DATE: JUN 17 2014
REPLY TO
ATTN OF: AMRP:RFG/14-AMRP-0219
SUBJECT: RECOMMENDATIONS FOR FUTURE IRRIGATION AT THE 331 BUILDING
TO: Memorandum to File

Recommendations for Future Irrigation at 331 Building

2012 aerial photo of 331 and vicinity with areas discussed in this document noted. Note shadows on north end of building due to aerial photography.

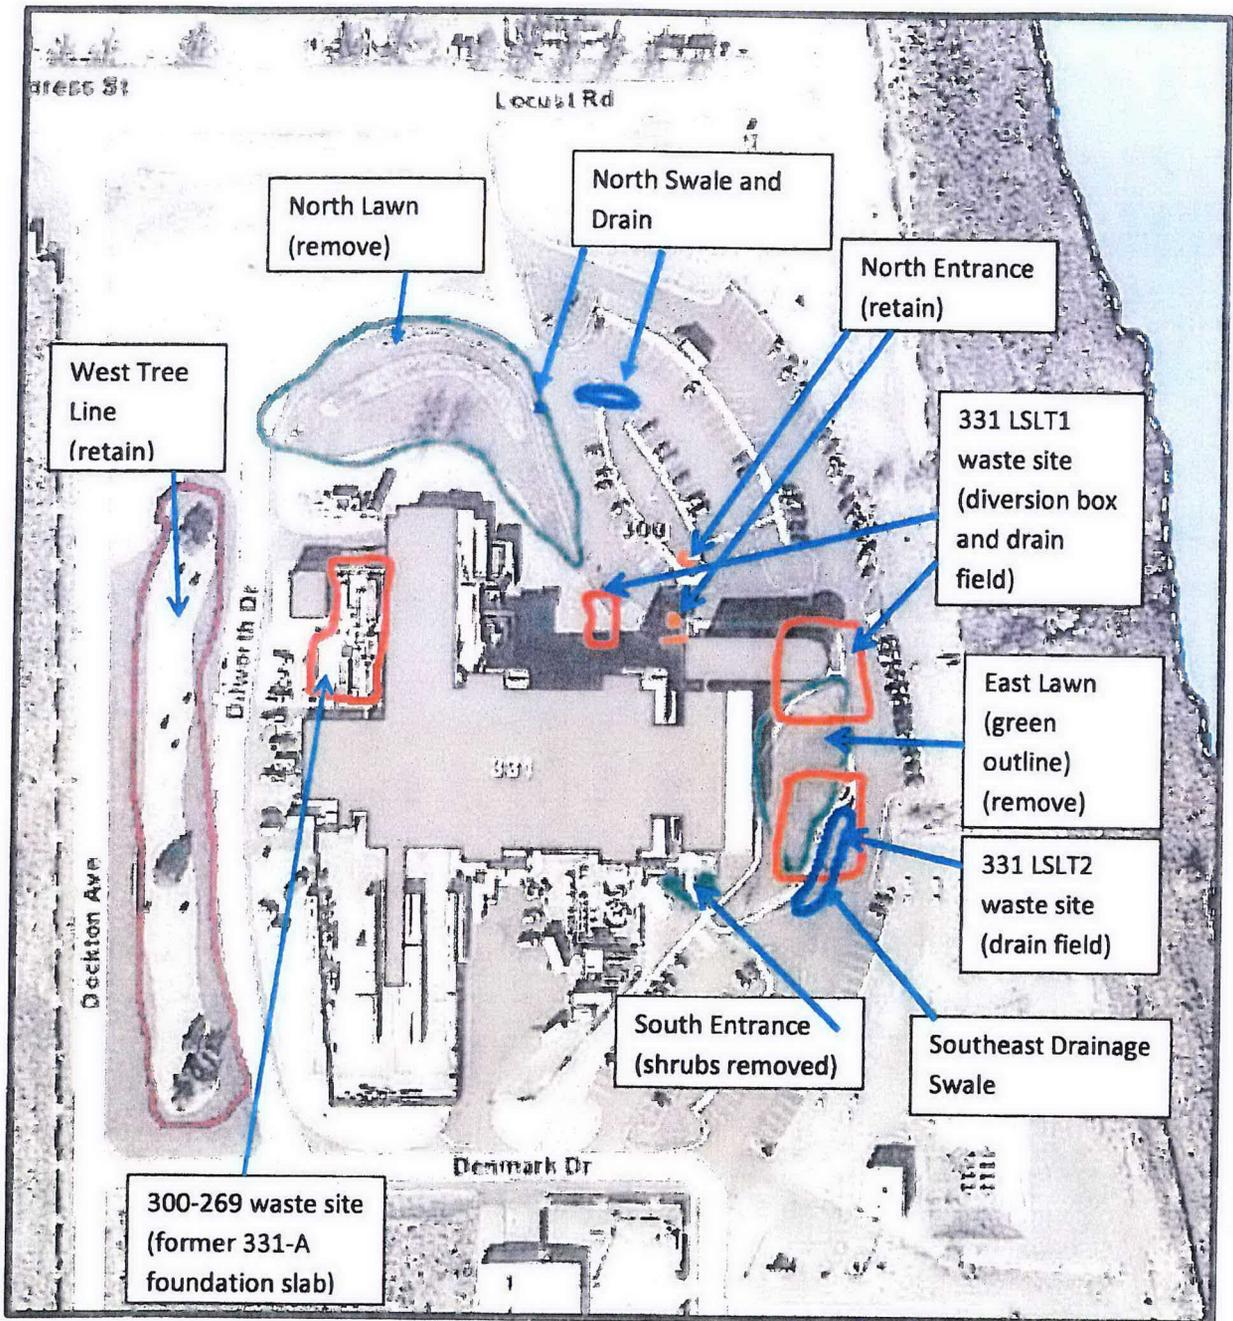
For the North entrance shrubs, the waste site is 20 feet away, under the building. There is a parking lot separating it. I do not consider this site to be in the vicinity.

The trees on the west side are approximately 100 feet away from the already temporary capped 300-269 waste site.

They are not in close proximity; the first picture will help with visualization

If I remember correctly there is no wastes in the vicinity of the area they plan to irrigate, correct? If that is the case EPA approves the use of irrigation at the 331 area.

I concur. Ask them to not over water A common problem in our area.

Tree line west of 331 (looking northeast, 331-BA is in the background)

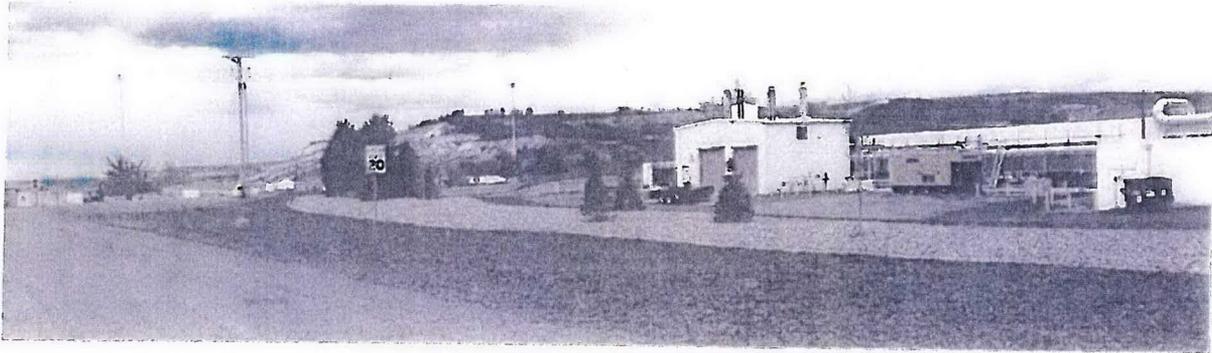
West Tree Line: 19 trees are planted in a rock area west of the 331 Building. The trees are watered using shrub heads (2 per tree). DOE requests the continued localized irrigation of this area continue and the trees be retained. Information supporting this recommendation:

- The rock area is roughly 100' west of the nearest waste site, 300-269 (the former 331-A Building slab).
- 300-269 is already considered interim stabilized (adequately covered). As a result, no barrier on the site will be installed.

Shrub head used to irrigate tree part of the tree line west of 331. Each tree has at least one shrub head to water it.

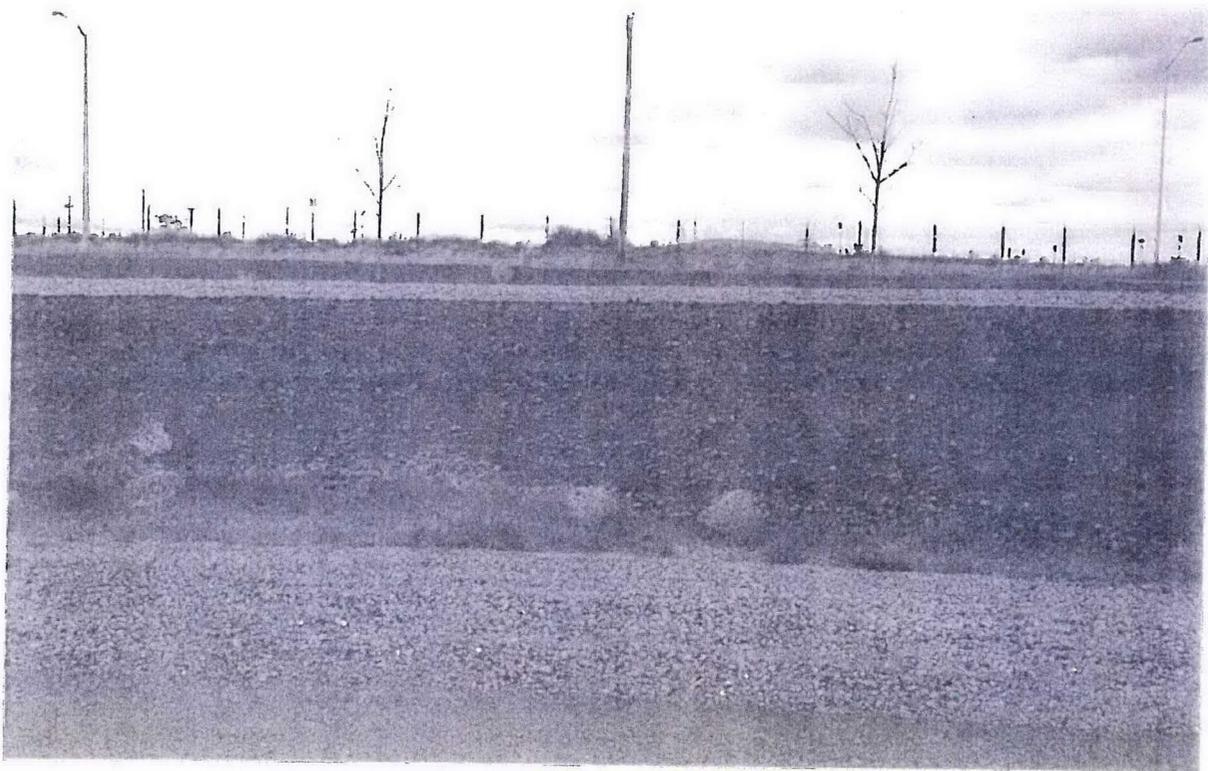
- The irrigation is operated for 30 minutes per day, three days/week. Water flow is adjustable at each shrub head, but is believed to be set at approximately 3.5 gpm. (Irrigation could be reduced if determined to be necessary.)

Roughly 4' drop between elevation of tree line and Dilworth Drive (looking west from Dilworth)

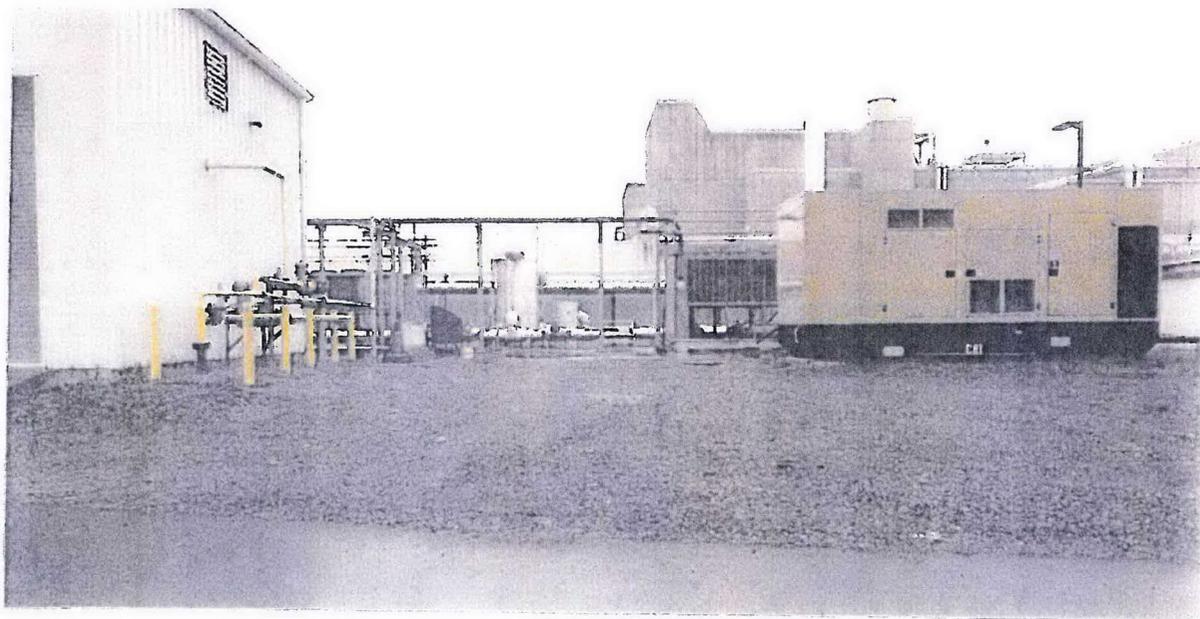
- The rock area is roughly 4' higher than the street that runs between it and the 331 Building (called Dilworth Drive in the map tool). The 300-269 slab is roughly 2' higher than Dilworth Drive. Dilworth Drive is sloped from north to south. Hence any inadvertent overwatering would run off to Dilworth Drive and thus to the south. It would not reach 300-269.

Planter area just outside the north entrance to 331. Two shrub heads.

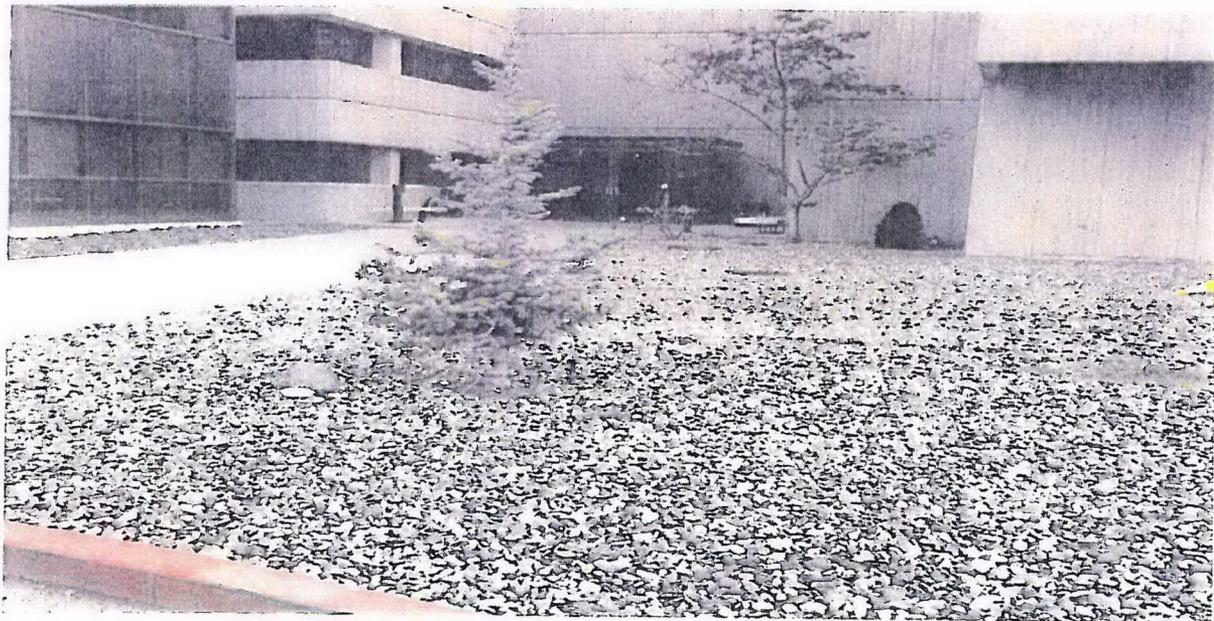
North Entrance: A few small trees and shrubs are planted in the vicinity of the North Entrance to the 331 Building. These are watered using shrub heads. DOE recommends that irrigation of this area continue and the plantings be retained. Information supporting this recommendation:
